**PLANNING BOARD AGENDA**

**JUNE 09, 2025  
REGULAR MEETING**

**Re: Papa Variance Application  
1701 Newman Street  
Block 7, Lot 1.01**

## PLANNING BOARD APPLICATION

## SITE PLAN

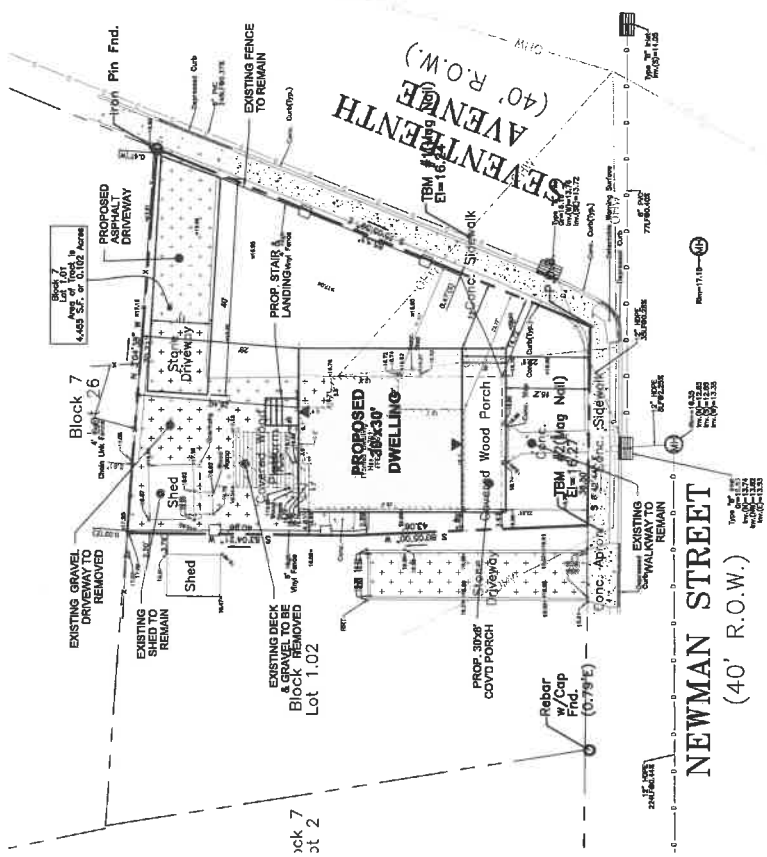
2. The Applicant did not provide architectural plans as part of the Planning Board application. The Applicant included a page in the denied Zoning Board application depicting the height of the proposed dwelling as 30.9 feet. The height of the proposed dwelling is not reflected on the site plan or on an elevation plan, and thus cannot be measured against the curb, as established in Code Section 17-7. The Board should elicit testimony to determine the proposed dwelling height and condition any approval on the submission and approval of architectural plans drawn to a recognized scale.

3. Code Section 17-7 specifies that all open front porches which project into the front yard setback must also be one-story. The covered porch is not depicted on the elevation document attached to the Zoning Application. The Board should elicit testimony to determine what is proposed above the covered porch and further require complete architectural plans depicting the entire proposal.

4. The Site Plan does not depict the proposed grading and drainage for the property. The grading depicted on the Site Plan matches that found on the Boundary and Topographic Survey. The Board should elicit testimony regarding the proposed grading and drainage on the site to prevent impacting neighboring properties, and further condition any approval on submission and approval of a Grading and Drainage Plan as required by ordinance.

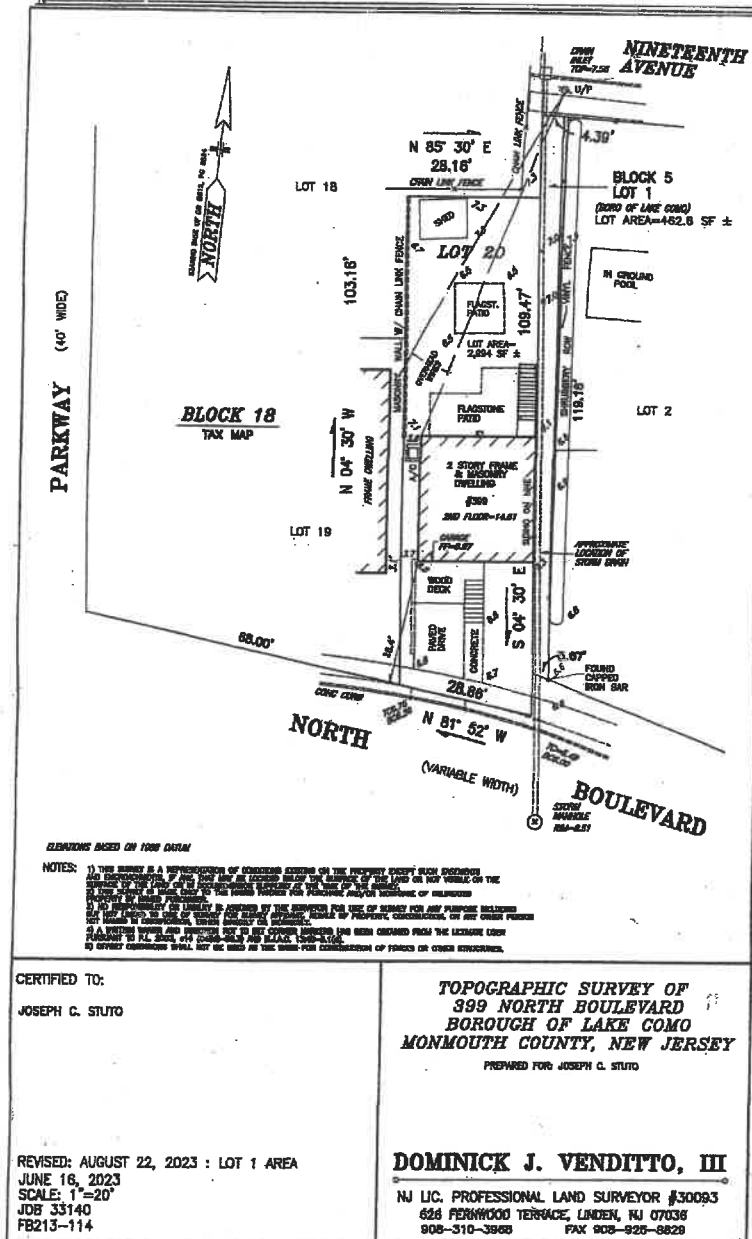
\* The values reported above for Building Height, Building Area, and Impervious Area differ from the table on Sheet A-2 of the Architectural Plans. The values utilized in the table were not reproducible and were found to be variance conditions by our calculations which were based on scaling of the provided plans.

My submitted drawings revision dated 1/4/2025 were numerically dimensionally correct, however, some of the drawings were slightly out of scale graphically. The numbers shown were all correct but some of the drawings were slightly out of scale.

As per Alan Hilla's request, I have redrawn everything so that the drawings are now both graphically and dimensionally correct. These redrawn drawings have been dated 1/20/2025.
